URFO:GRK  
 Docket No. 40-6659  
 SUA-551, Amendment No. 11  
 04006659261E

MEMORANDUM FOR: Docket File No. 40-6659

SUBJECT: AMENDMENT NO. 11 TO SOURCE MATERIAL LICENSE SUA-551

FIGURE 1 - TAILINGS MANAGEMENT SYSTEM

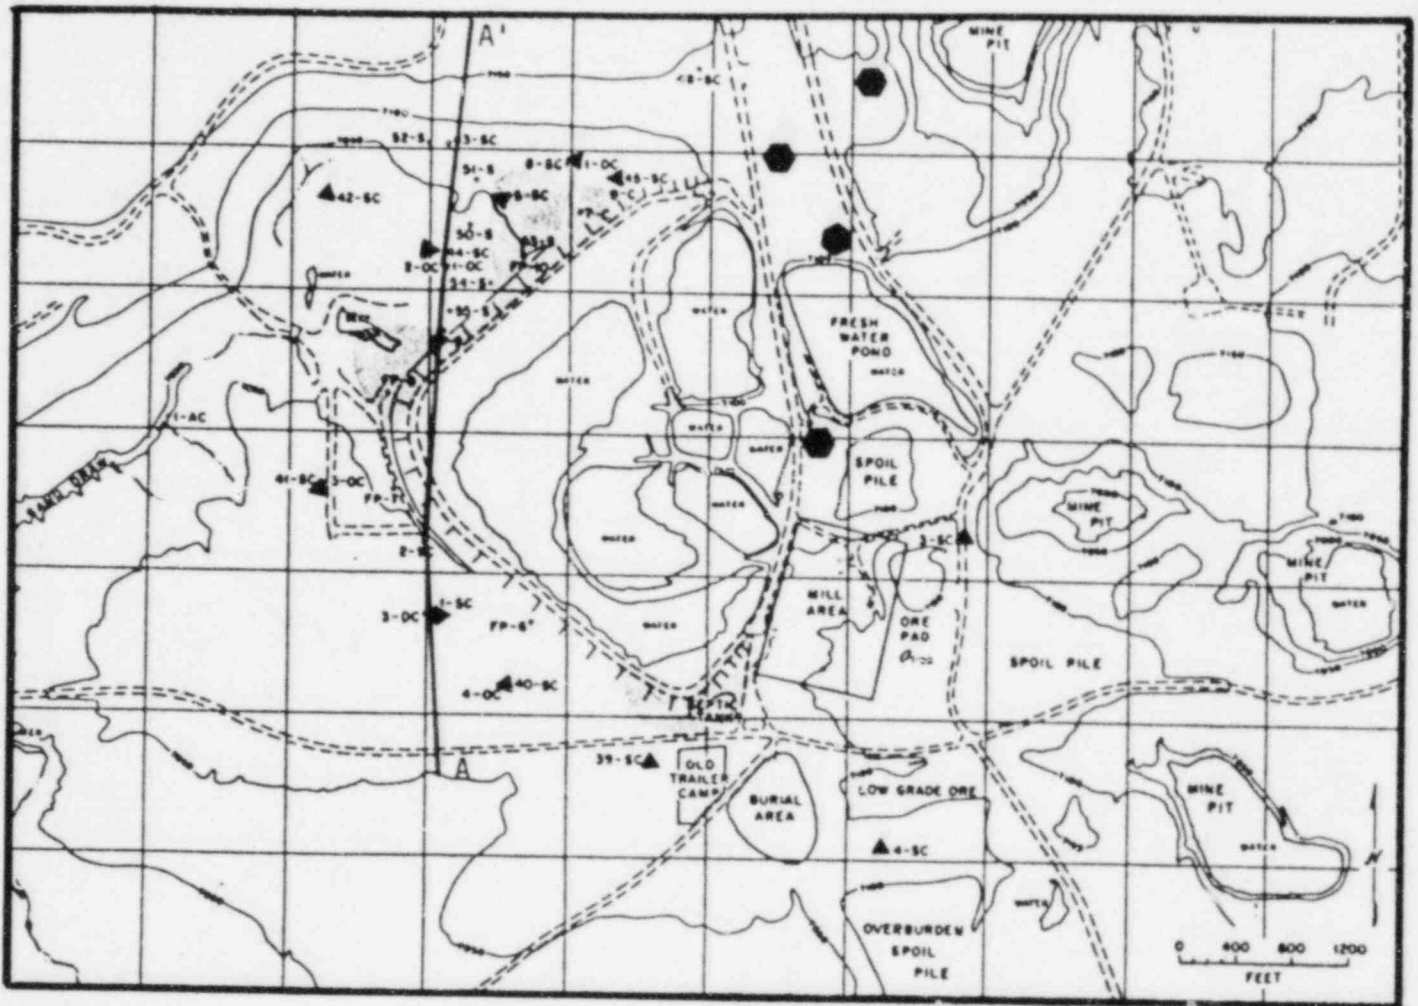
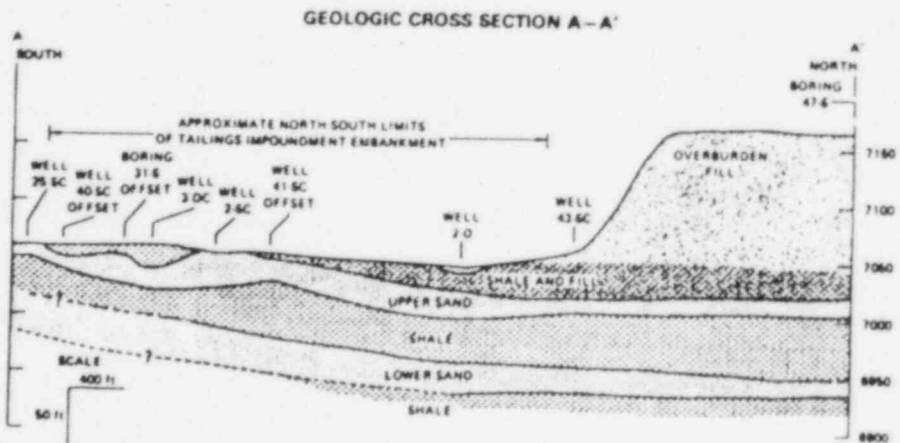
Because much has been learned about the tailings management system and the associated seepage, the current set of ground water monitoring wells was considered to be inadequate. In response to this, Petrotonics proposed to utilize a series of SC (shallow cased) wells and some of the existing wells in their ground water monitoring program. Table 1 compares the existing and proposed ground water monitoring wells. Figure 1 shows the proposed sampling wells and the known zones of seepage.

Previous studies indicate that tailings derived seepage from the Petrotoxic's tailings impoundment appears to be confined to the Upper Sand. Due to this, the staff concludes that the Upper Sand should be the unit which receives the majority of the monitoring. However, as a check to assure that if seepage should contaminate the Lower Sand it does not go undetected, one well (new RTH 1 or IDC) should be redrilled and sampled in this unit. As a further check on the Lower Sand, Petrotoxic has proposed to redevelop wells old RTH 1 and RTH 3. The redevelopment effort will take place in the Summer of 1985. The staff feels that the redevelopment of these wells is very important to the groundwater monitoring program and will require, by license condition, that if redevelopment of these wells is unsuccessful, then they will be redrilled adjacent to their existing locations. For a geologic cross section, which shows the Upper and Lower Sand units, see Figure 1.

- B. Redevelop or redrill Wells IDC, RTH 1 and RTH 3 as well as complete four additional monitoring wells, in the Upper Sand aquifer, in the area north and east of the tailings impoundment. Completion details shall be submitted to the USNRC, Uranium Recovery Field Office, by June 30, 1986.

FIGURE 2- PETROTOMICS PROPOSED EVAPORATION SYSTEM

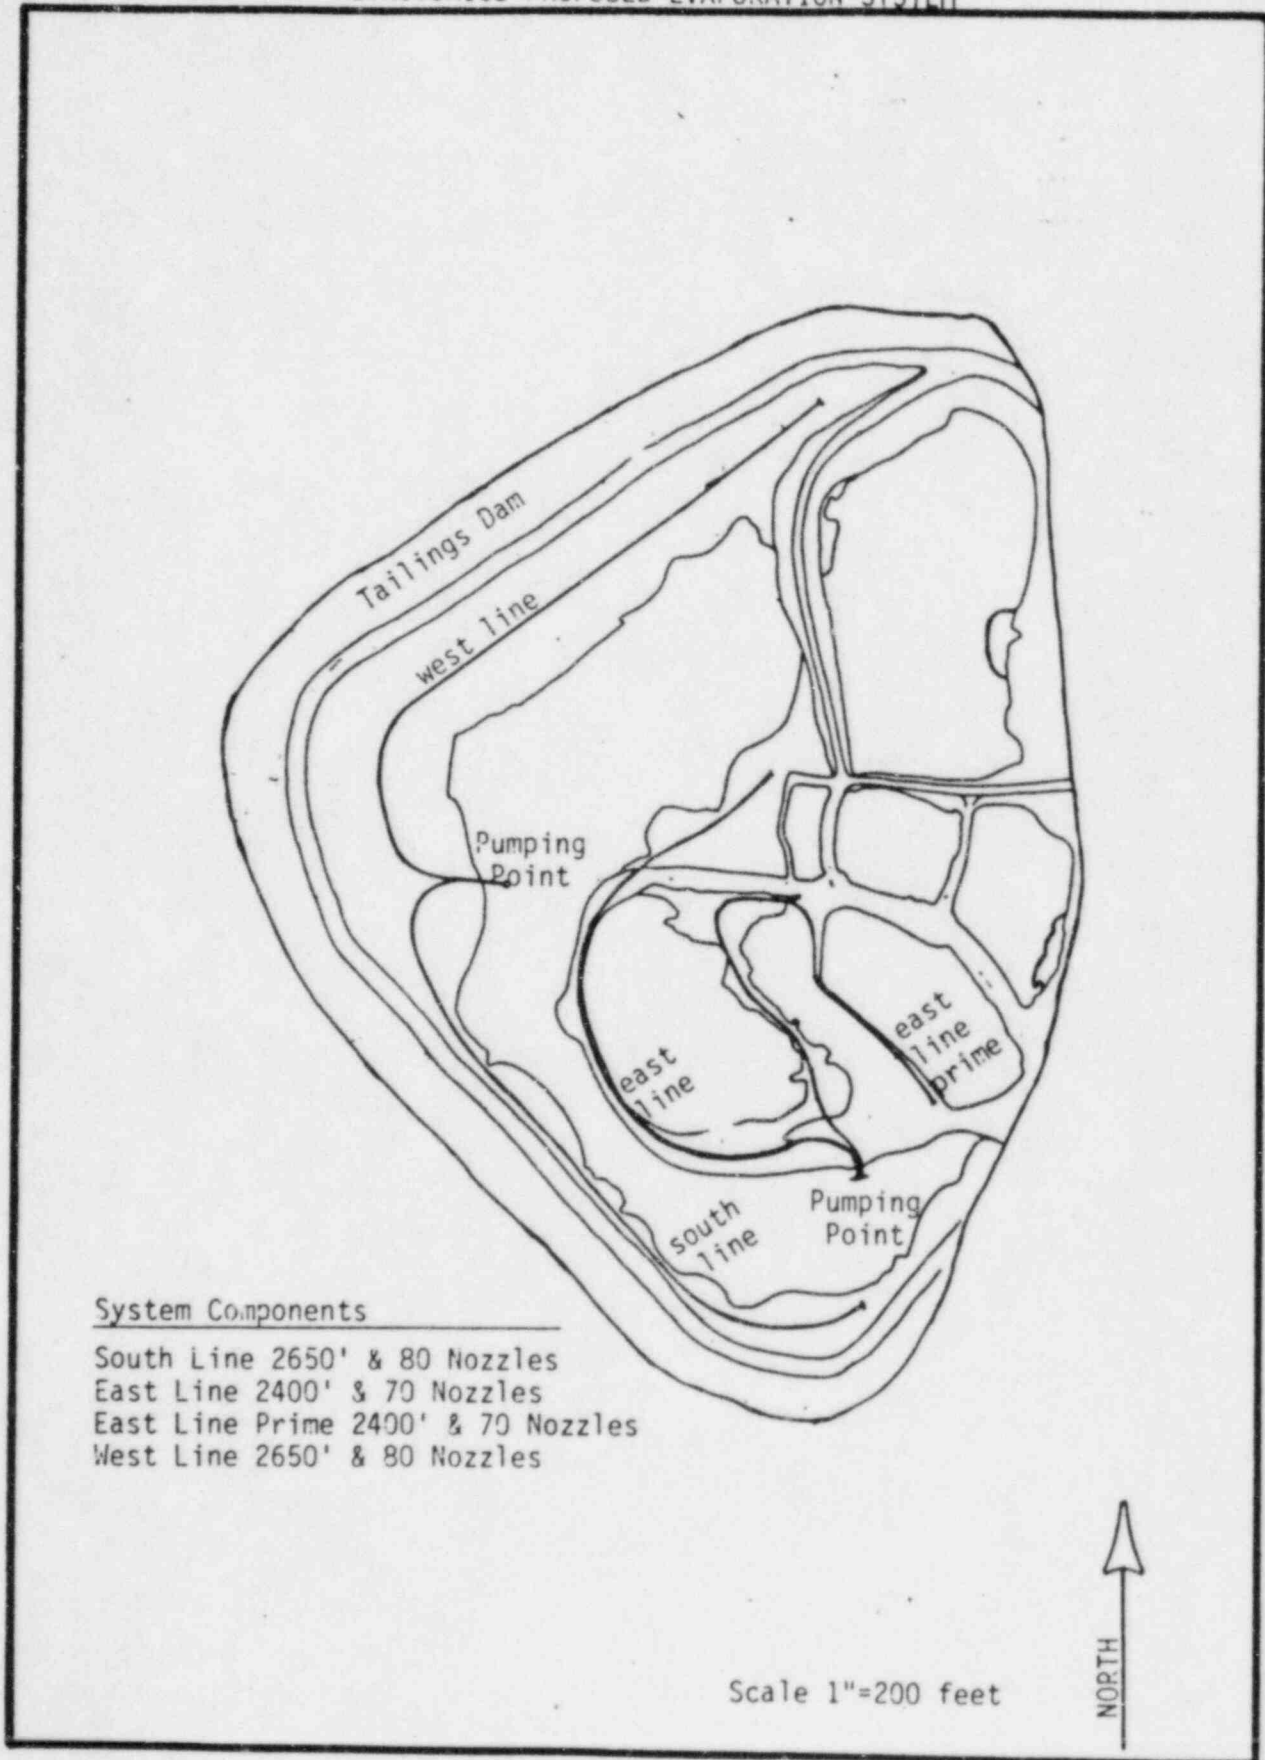
As stated in the background discussion, Petrotomics was directed by License Condition No. 36 to study and propose an implementation schedule for an enhanced ground water remedial action program. In response to this Petrotomics included in their April 1, 1985 submittal a proposal for enhanced tailings solution evaporation. The proposal consists of four lines of spray nozzles. The lines have 70 to 80 spray nozzles which are mounted on risers attached to the main discharge lines. Table 2 shows the predicted evaporation potential of the system and Figure 2 shows the layout of the proposed enhanced evaporation system.

concur with the idea of eliminating the free water surface in the tailings impoundment and thereby reducing the driving force behind the seepage water. The system as proposed would totally evaporate the tailings solution in 2.5 to 3.0 years. This estimate is very conservative, based upon the 10% to 23% estimated evaporation rate which the staff feels should be closer to 20% to 40%. Regardless of the actual evaporation rate the staff finds the proposed system to be an effective means of reducing the driving force behind tailings impoundment seepage into the underlying aquifer.

As designed, the proposed evaporation system will eventually eliminate the free liquid in the tailings impoundment. At this time the staff will review the total tailings management system (evaporation system, dust suppressant system and seepage collection) to determine the appropriate course of action. The staff realizes that there will be a point in time when the seepage collection system will lose its efficiency and eventually require reduced operating time and potentially elimination.

- C. Maintain, at a minimum, the enhanced evaporation system as described in the April 1, 1985 submittal. Furthermore, the licensee shall maintain the seepage recovery system
